## PUBLIC UTILITIES COMMISSION

**RE: Deficiency Report #4 - Certificate of Public Convenience and Necessity for the  
Riverside Transmission Reliability Project – Application No. A.15-04-013**

# DEFICIENCY REPORT #4 FOR THE RIVERSIDE TRANSMISSION RELIABILITY PROJECT APPLICATION (A. 15-04-013)

**CPUC Riverside  
Work Area Constraints  
Mapbook**

Map 3 of 22

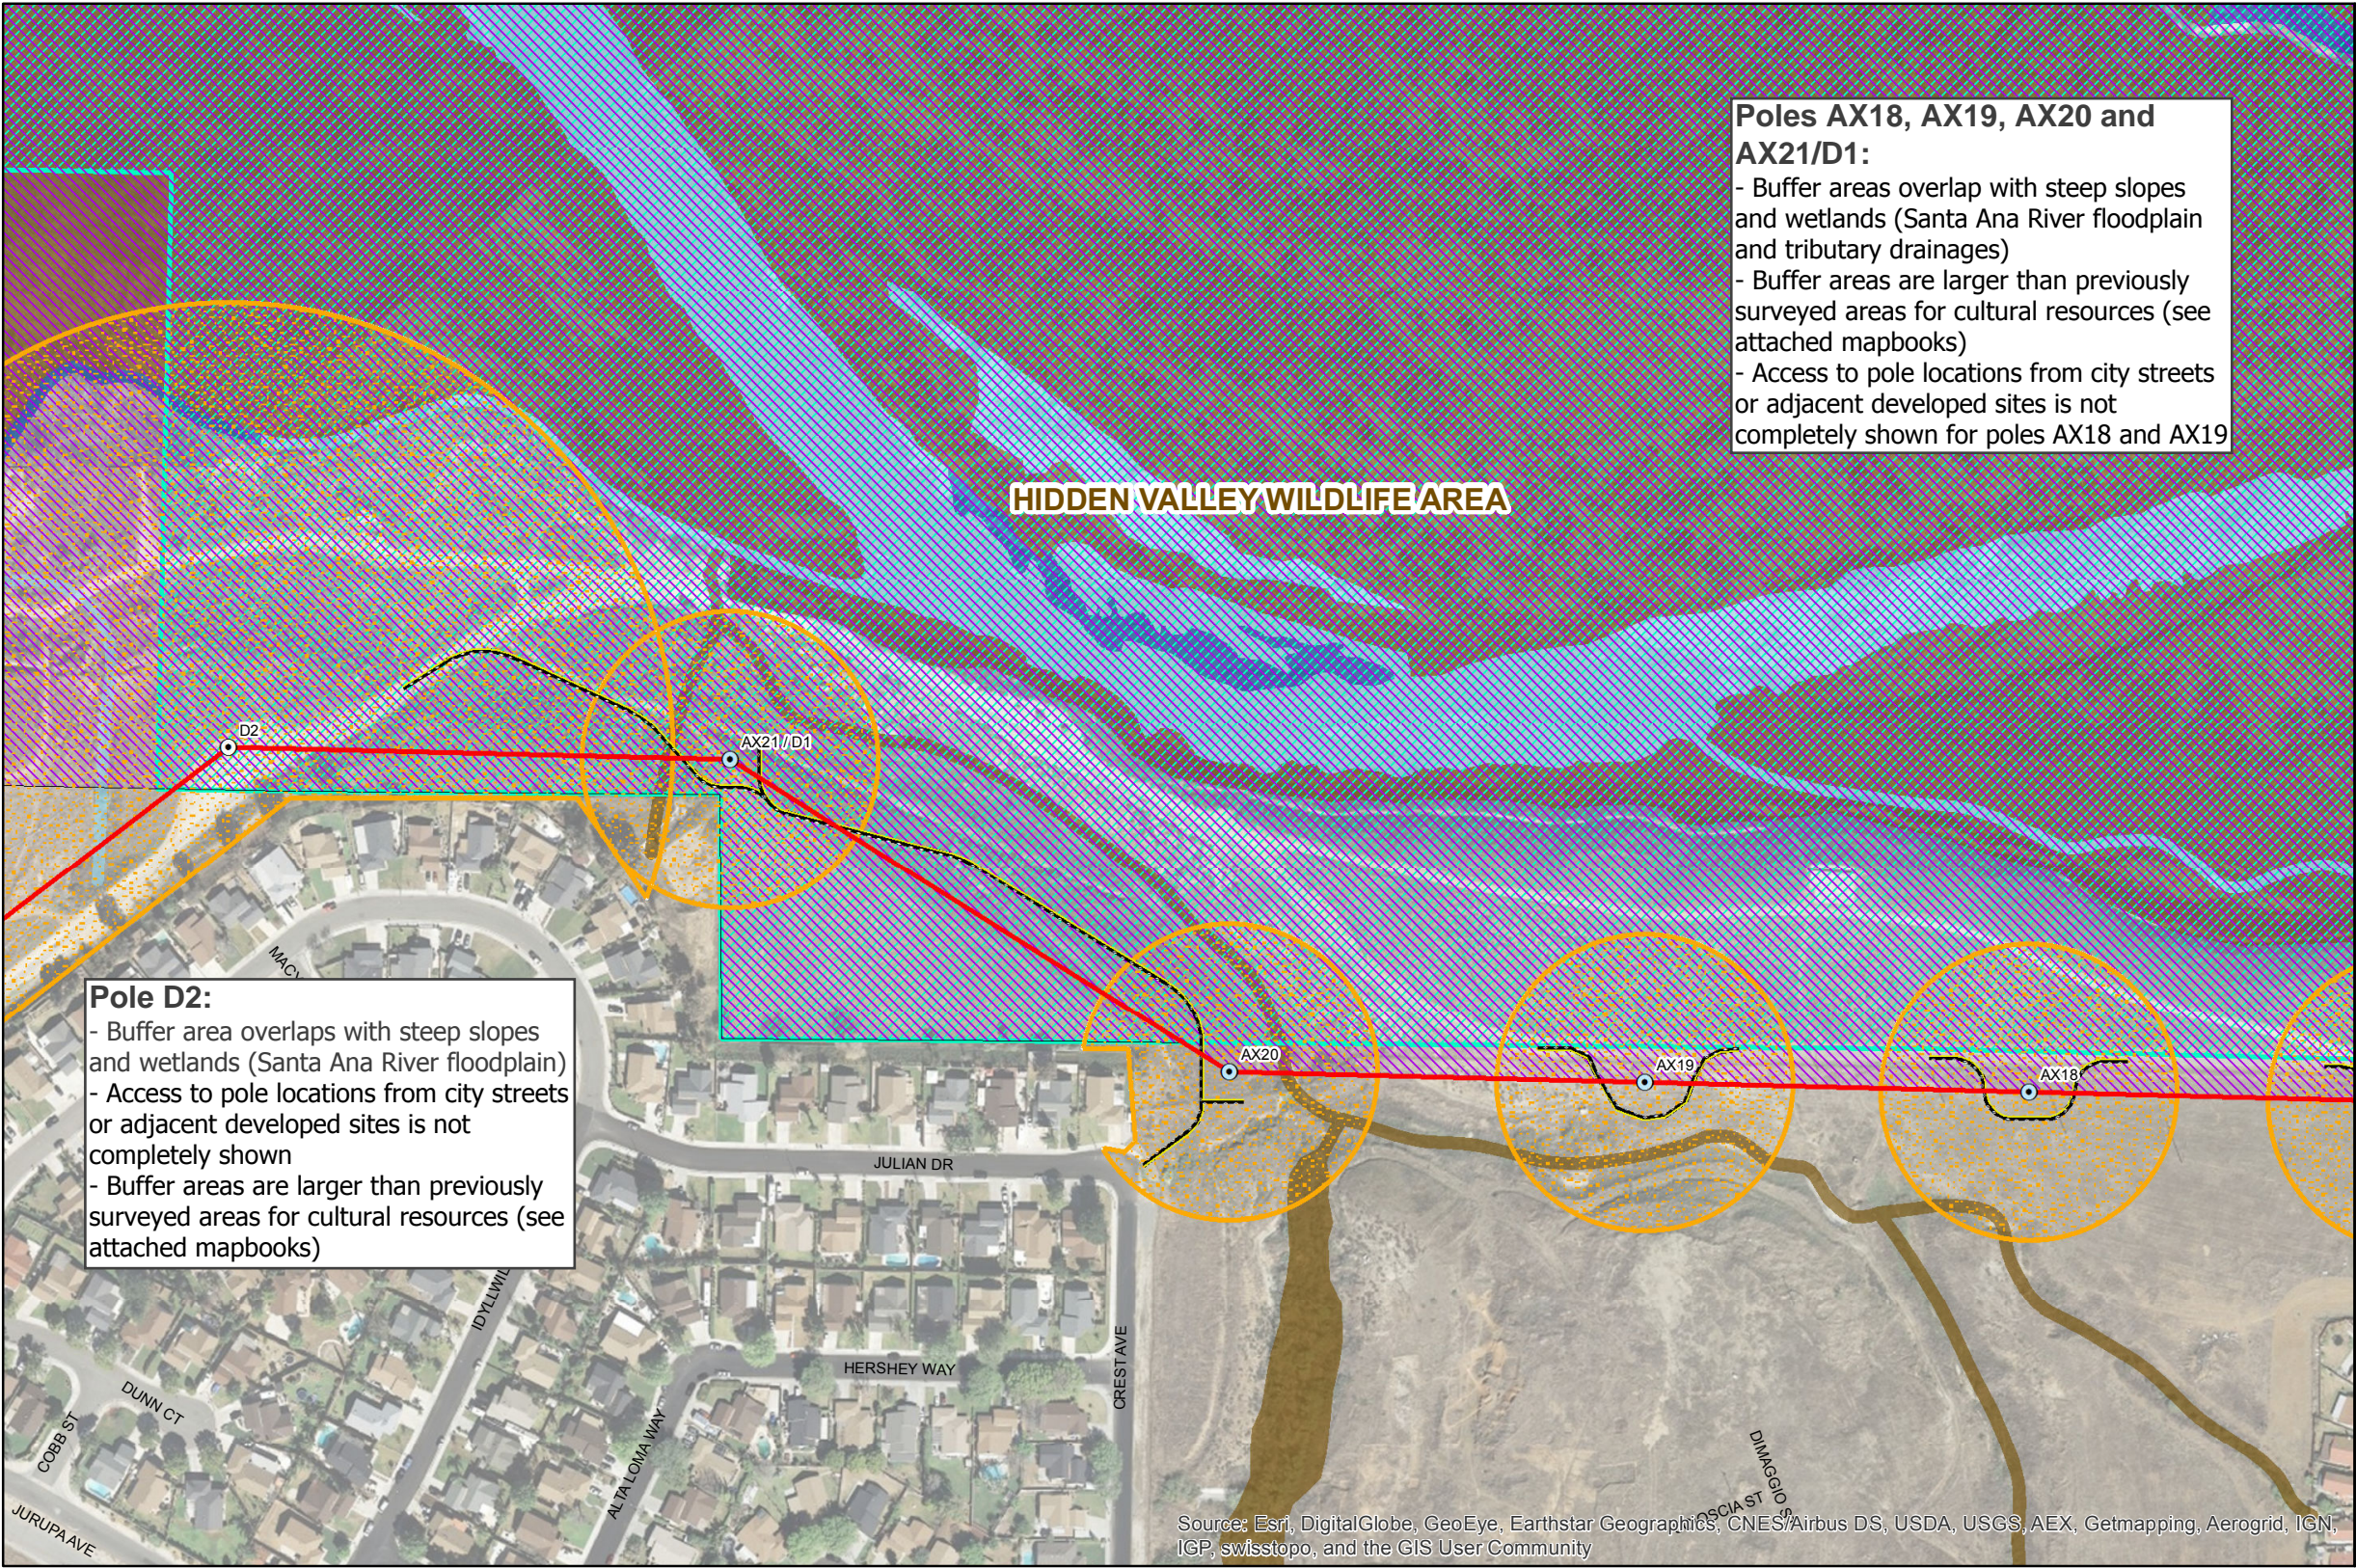
**Poles NO-10 through NO-12:**

- Buffer areas overlap with Santa Ana River floodplain
- Access to pole locations from city streets or adjacent developed sites is not shown
- Buffer areas overlap with Riverside Water Quality Control Plant facilities
- Pole NO-12 buffer area overlaps with Van Buren Avenue (potential for road closure?)

**Poles AX15, AX16 and AX17:**

- Buffer areas overlap with steep slopes and wetlands (Santa Ana River floodplain and tributary drainages)
- Buffer areas are larger than previously surveyed areas for cultural resources (see attached mapbook)
- AX 15 buffer area overlaps with Riverside Water Quality Control Plant facilities and Van Buren Avenue (potential for road closure?)
- Access to pole locations from city streets or adjacent developed sites is not completely shown

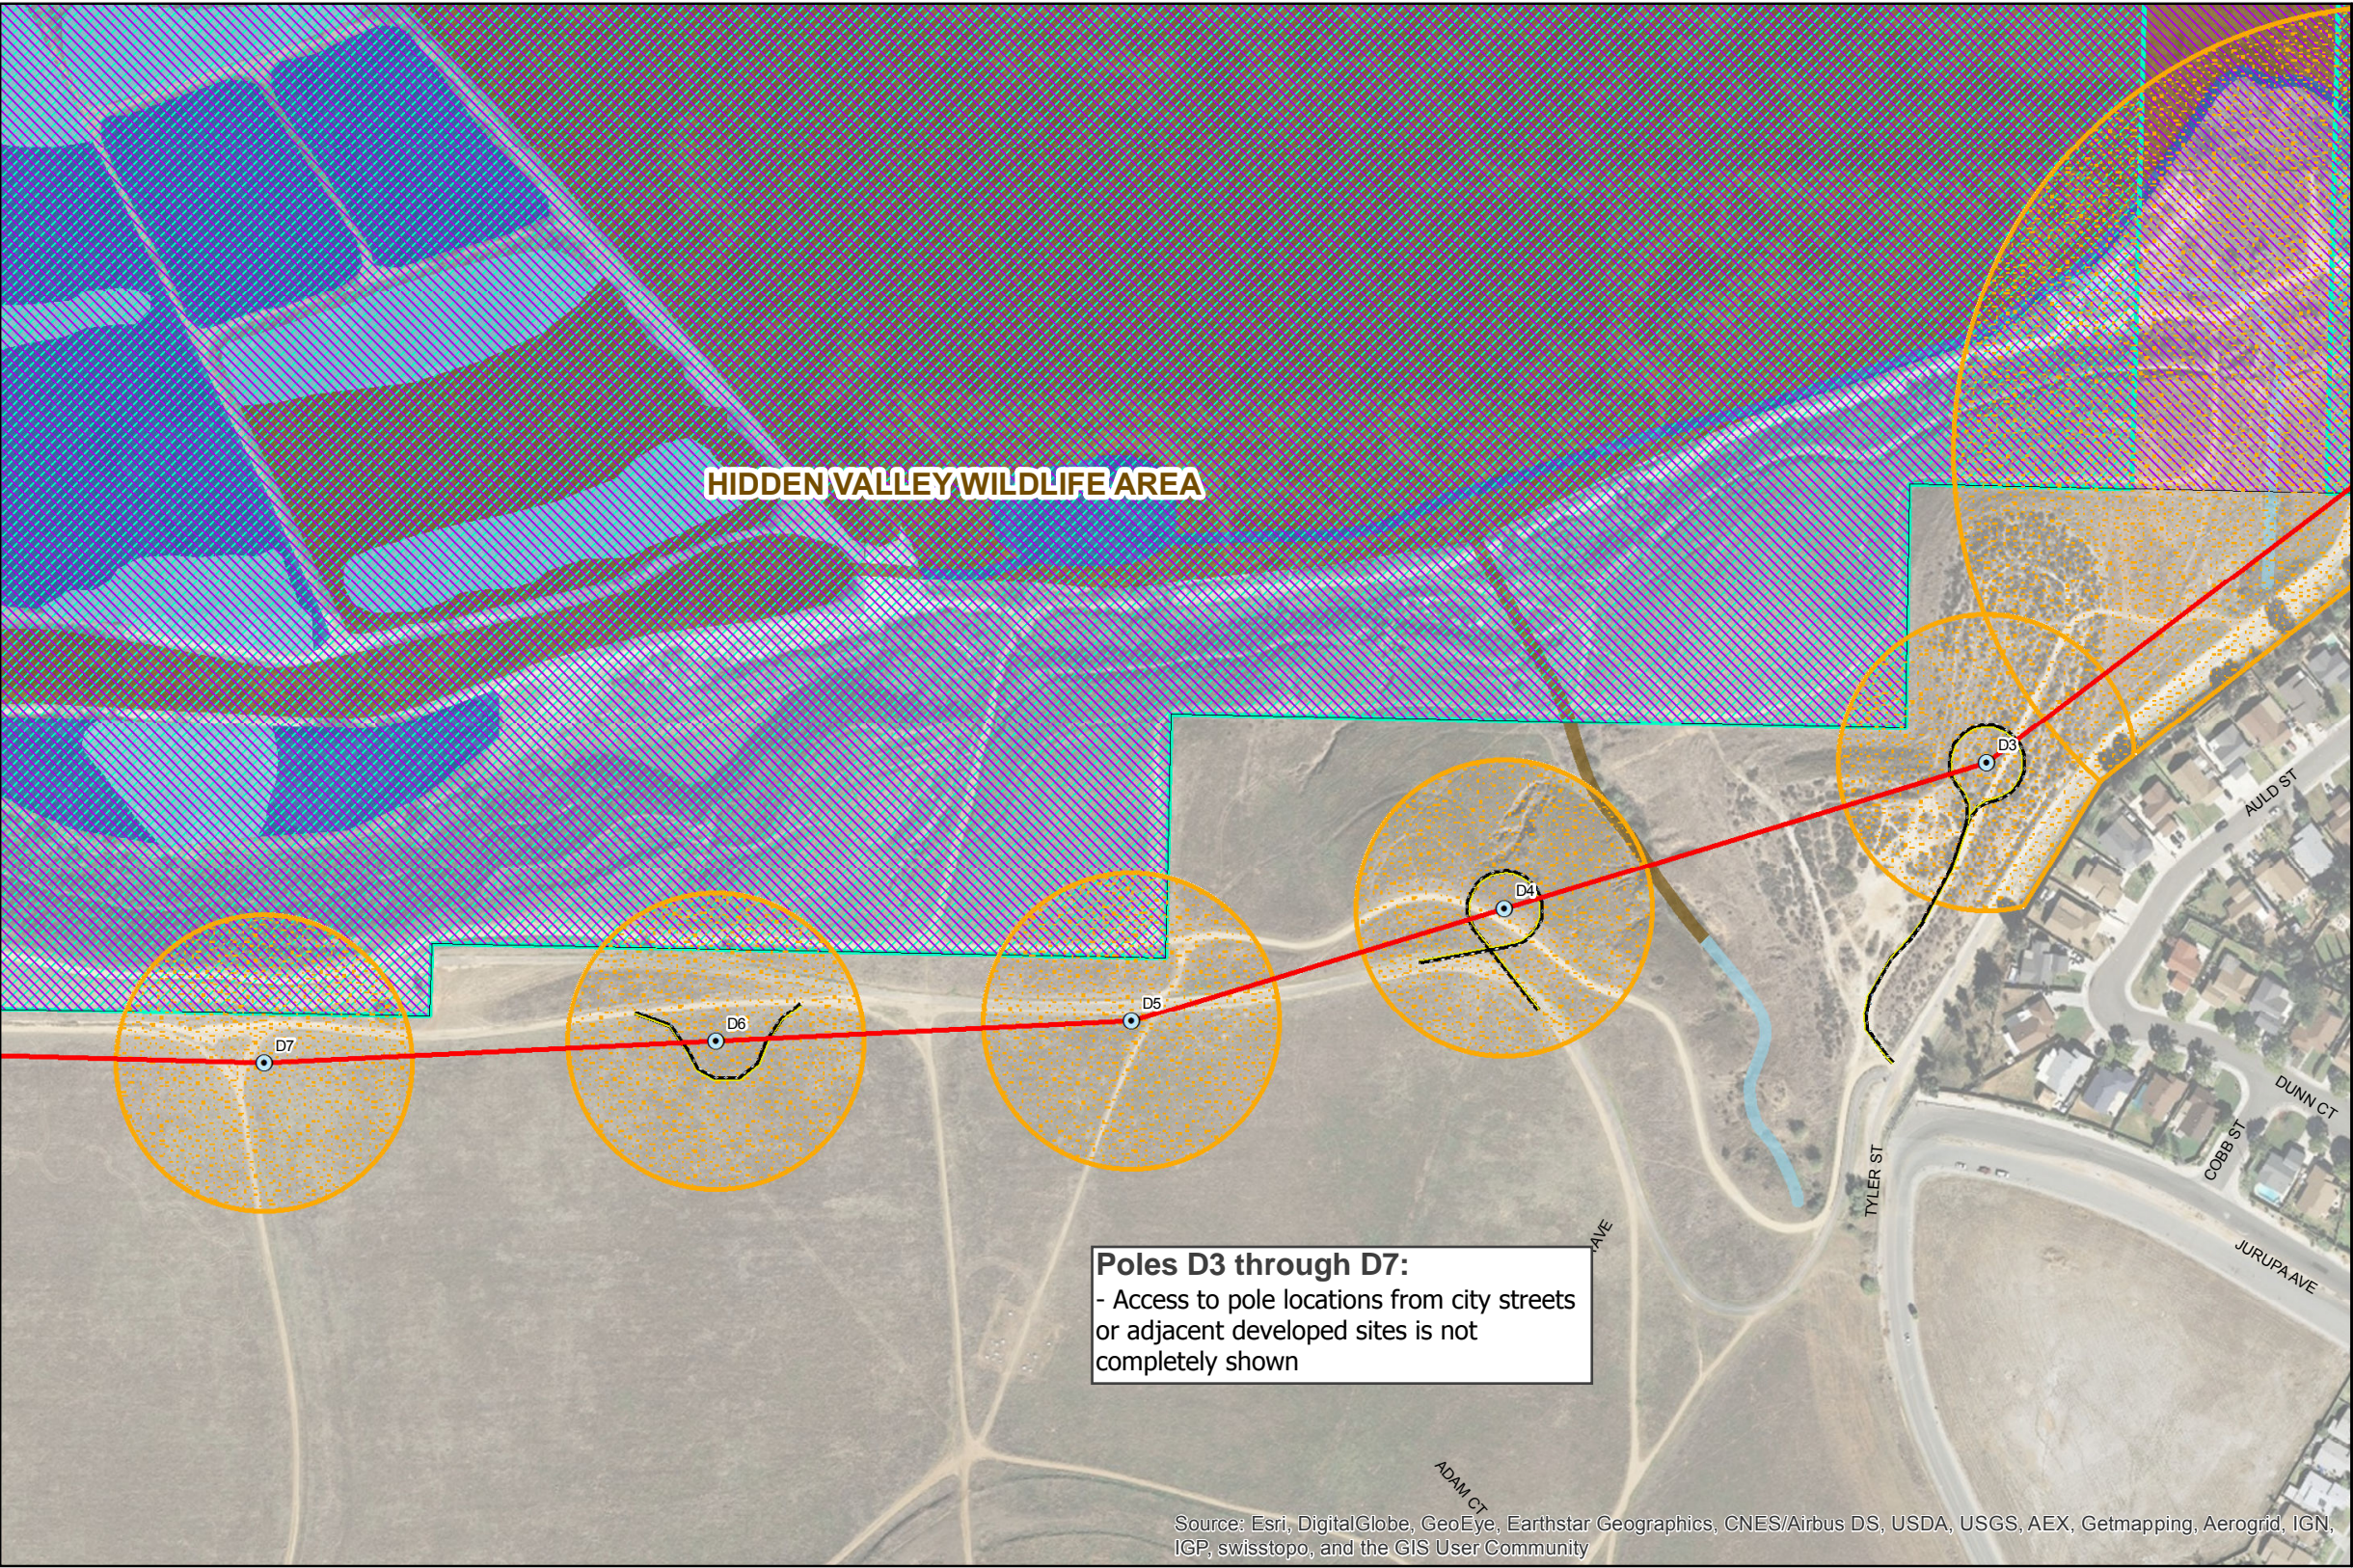
**Poles AX18, AX19, AX20 and AX21/D1:**

- Buffer areas overlap with steep slopes and wetlands (Santa Ana River floodplain and tributary drainages)
- Buffer areas are larger than previously surveyed areas for cultural resources (see attached mapbooks)
- Access to pole locations from city streets or adjacent developed sites is not completely shown for poles AX18 and AX19

**Pole D2:**

- Buffer area overlaps with steep slopes and wetlands (Santa Ana River floodplain)
- Access to pole locations from city streets or adjacent developed sites is not completely shown
- Buffer areas are larger than previously surveyed areas for cultural resources (see attached mapbooks)
